City of Portland
Development Review Application
Planning Division Transmittal Form

Application Number: 2013-191

Project Name: Cumb Cty Teachers Federal Credit Union

Subject: Application ID: 2013-191

Site Plan - 2013-191

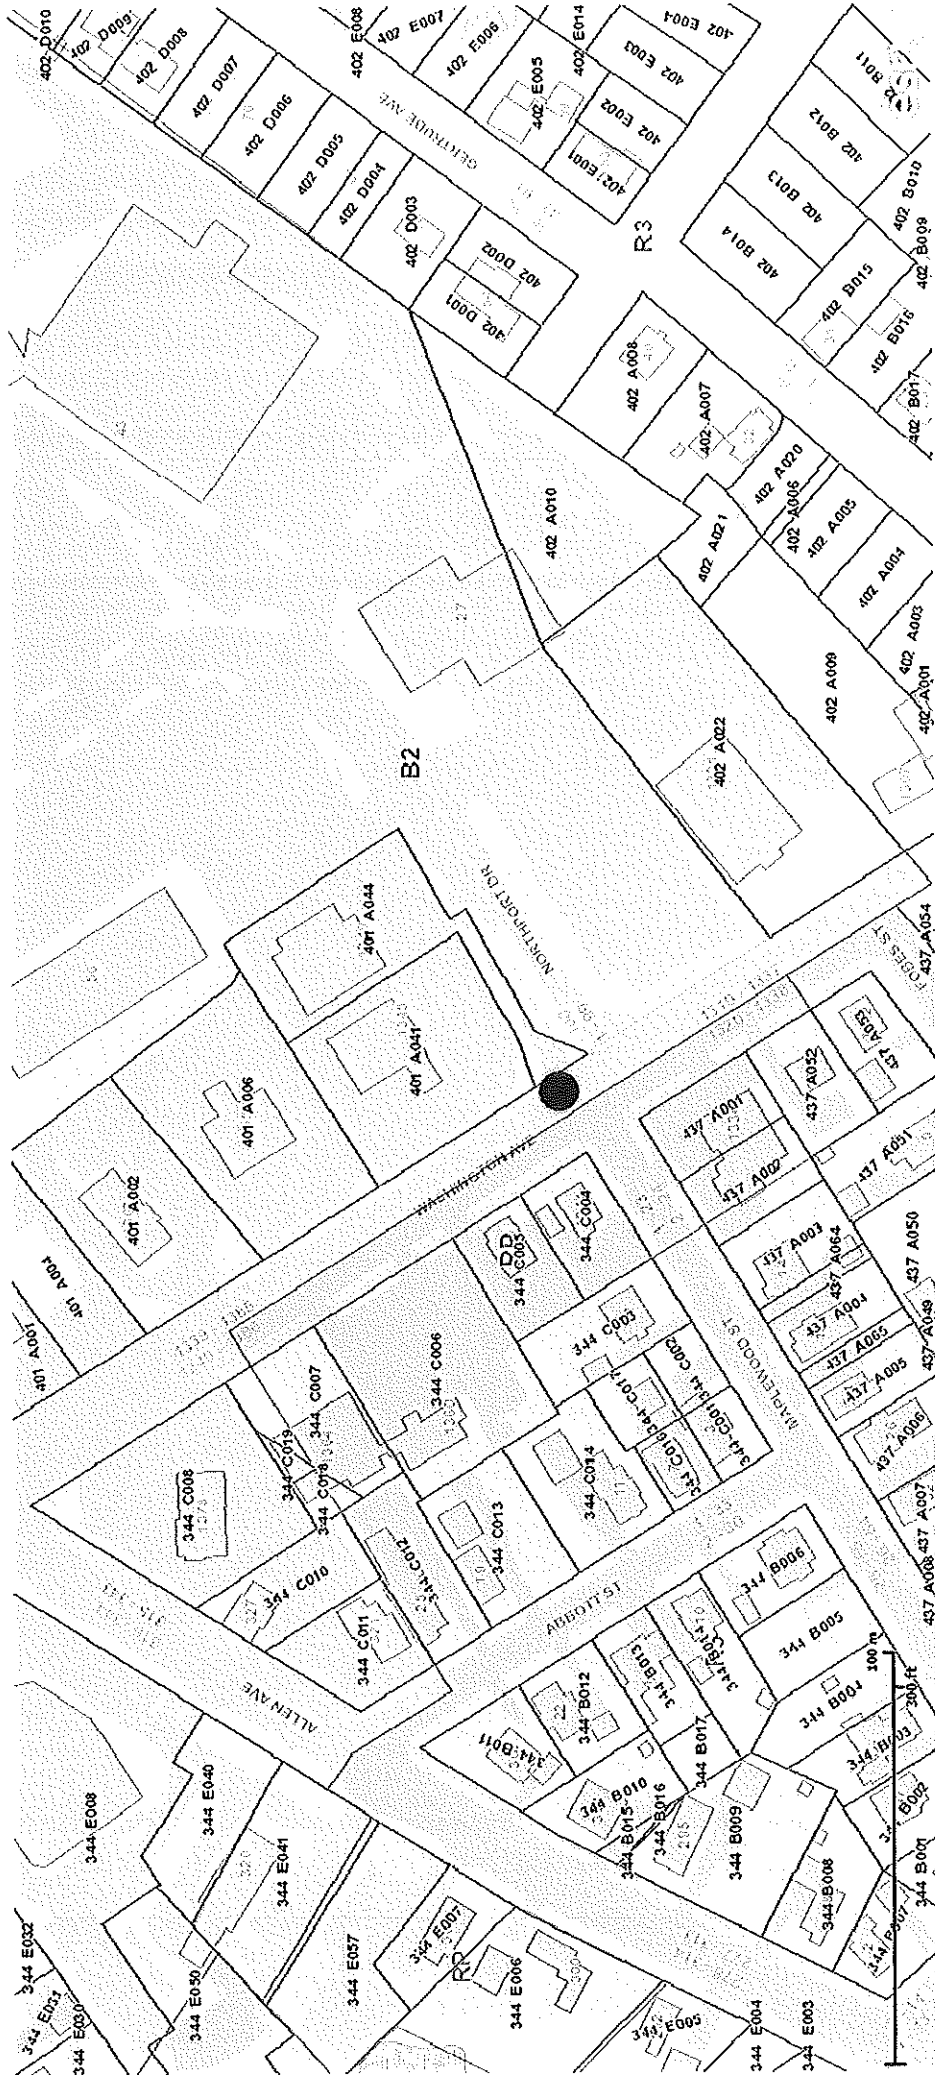
This project is doing improvements to an existing structure and property which is located in the B-2 zone. An new tower is proposed on one corner. It will be under the maximum allowable building height of 45 feet. There will also be some removal of impervious surface that brings the impervious surface ratio to 89.1% where 90% impervious is the maximum allowed.

Please note that separate permits are required for any new signage and that what is shown on the site plan is not being approved at this time.

All other B-2 requirements are being met at this time.

Lot Street Frontage - ~~None~~ 50'

Front Yard - ~~10' min~~ NO min req lot shown (44' to canopy of Drive Thru)

Rear Yard - ~~10' min~~ None 10' shown

Side Yard - ~~5' min~~ (doesn't abut res) - 22' & 34' (scaled)

Height - 45' max - 11x10 ≈ 21' shown

Lot Coverage/ Impervious Surface - 90% imp. reducing imp - 19,091 / 21,421 = 89.1%

Off-street Parking - 29 pkgs spaces shown 3,010^{sq} / 400 = 8 pkgs req
